### **Proposal for Supplement 14 to Regulation No. 50**

This proposed amendment is submitted by the expert from INDIA, in order to amend the requirements for front and rear direction indicators.

### Example Vehicles

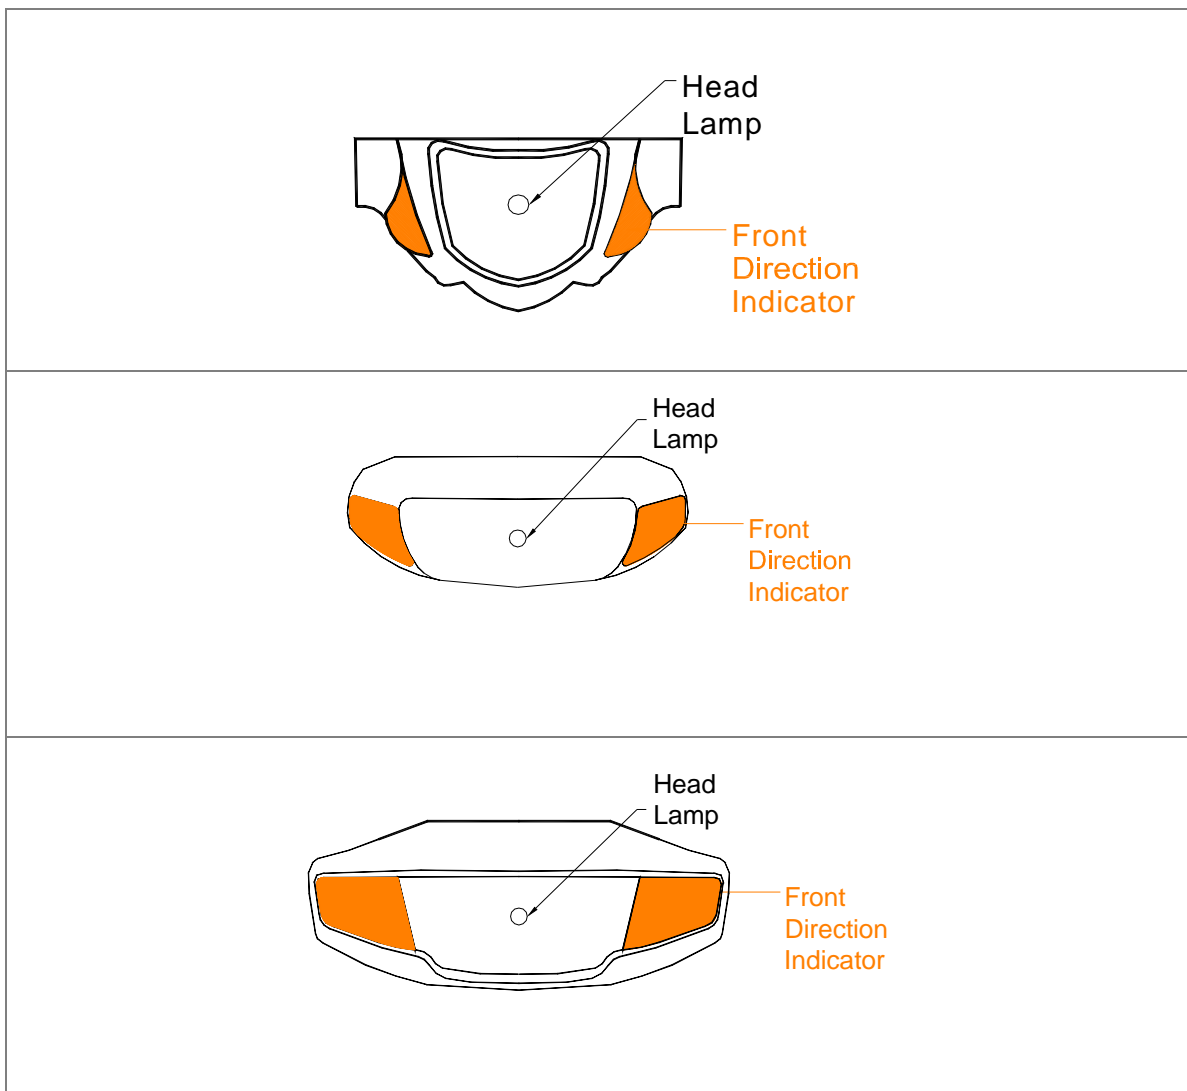
- There are designs being used today, where the front direction indicator lamps are grouped with the headlamp and rear direction indicator lamps are grouped together or with another lamp. Some of such examples are shown in the attached pictures.
- Considering the today's design concept, generally, more complex and having close tolerance, it is very difficult to verify this requirement on the installation of devices

Examples of Front Direction Indicators  
 Requirement: Minimum distance of 240 mm between illuminating surfaces of two front direction indicators

Examples of Rear Direction Indicators  
 Requirement: Minimum distance of 180 mm between illuminating surfaces of two rear direction indicators

**6.4.1.1 In case both the front direction indicators are grouped with any other devices there shall be a minimum distance of 240 mm between illuminating surfaces of two front direction indicators.**

**6.4.1.2 In case both the front direction indicators are grouped with passing beam headlamp the indicators shall be situated outside the longitudinal vertical plane tangential to the outer edges of the illuminating surface of the headlamp(s),**

**6.4.2.1 In case both the rear direction indicators are grouped with each other or with any other devices, the clearance between the inner edges of the two illuminating surfaces shall be at least 180 mm**
